**GOVERNMENT OF INDIA  
MINISTRY OF RAILWAYS  
(RAILWAY BOARD)**

No. 2006/CE-II/CS/1

*Sub: Advance Correction Slip No.102 to the Indian Railways Permanent Way Manual.*

**INDIAN RAILWAYS PERMANENT WAY MANUAL**  
**ADVANCE CORRECTION SLIP No. 102 dated 29.05.2007**

ANNEXURE 7/3 - PARA 716(2)

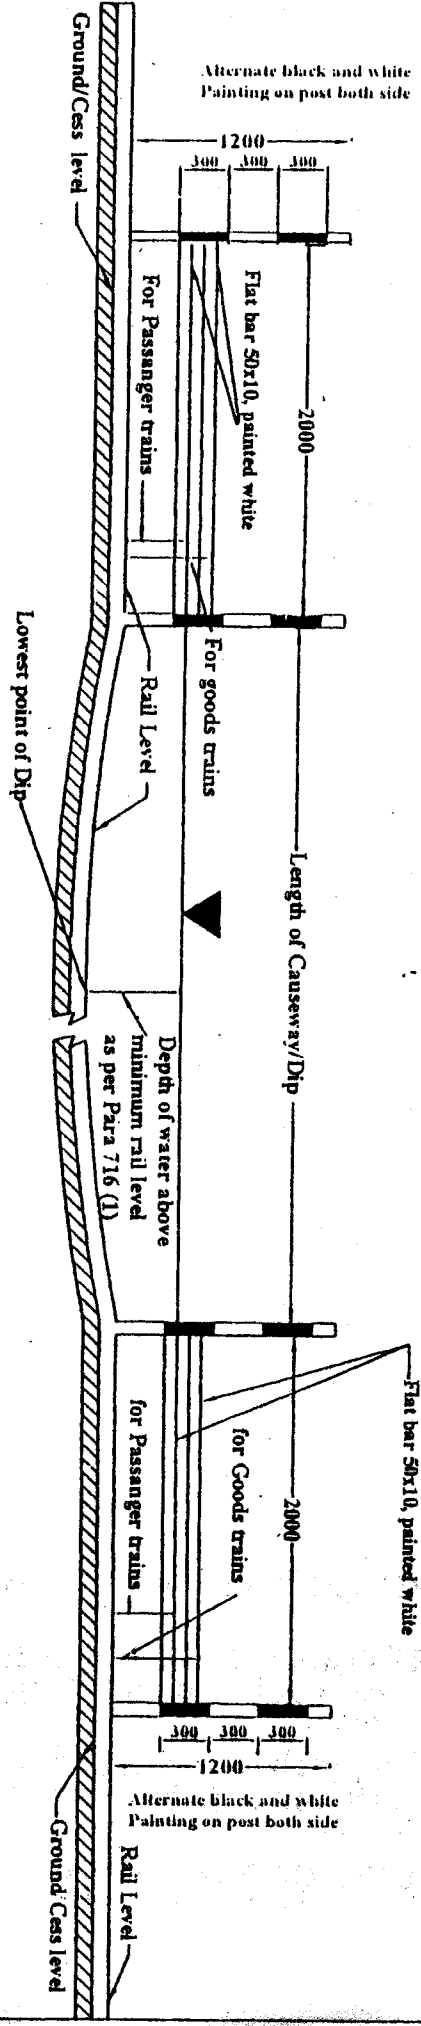
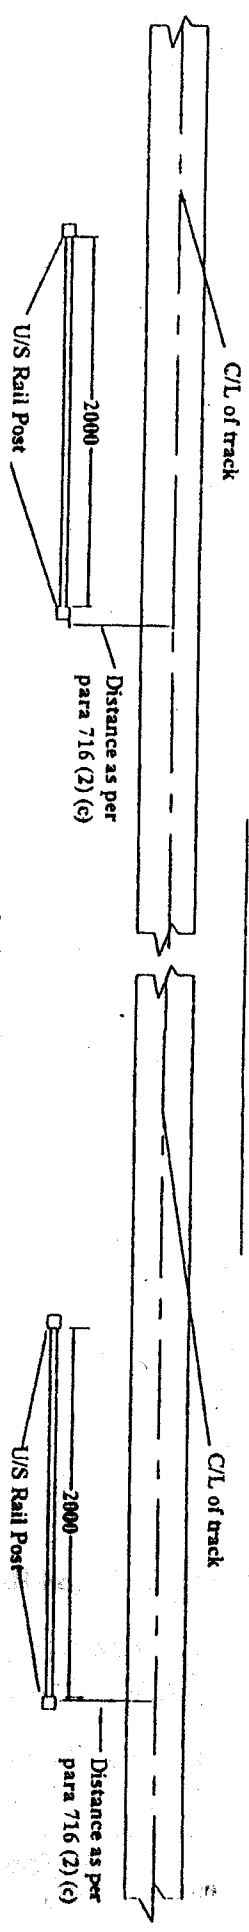
Kindly refer to advance correction slip to IRPWM referred under reference. It is to mention that one typographical error is there in the figure of para 716 (2) (a), namely the height of indication post, which has been mentioned as **120mm** instead of **1200 mm**. The corrected para 716 (2) (a) to be read as under:

**Para 716 Flooded Causeways/Dips:** (2) (a) Indication posts - Indication posts about 1200 mm. in height shall be fixed at each dip, one at each end of the level portion, with flat bar attached to them to indicate level mentioned in Para 716(1).

(b) The posts should be painted black and white in 300 mm. length so arranged that the flat bars which shall be painted white, show up against 300 mm. length of black colour.

(c) The posts shall be fixed 3 metres from the center of the track in the case of Broad Gauge and 2.5 metres from the center of track in the case of Metre and Narrow Gauge.

(d) The details for fixing indication Posts have been shown in Annexure 7/3.
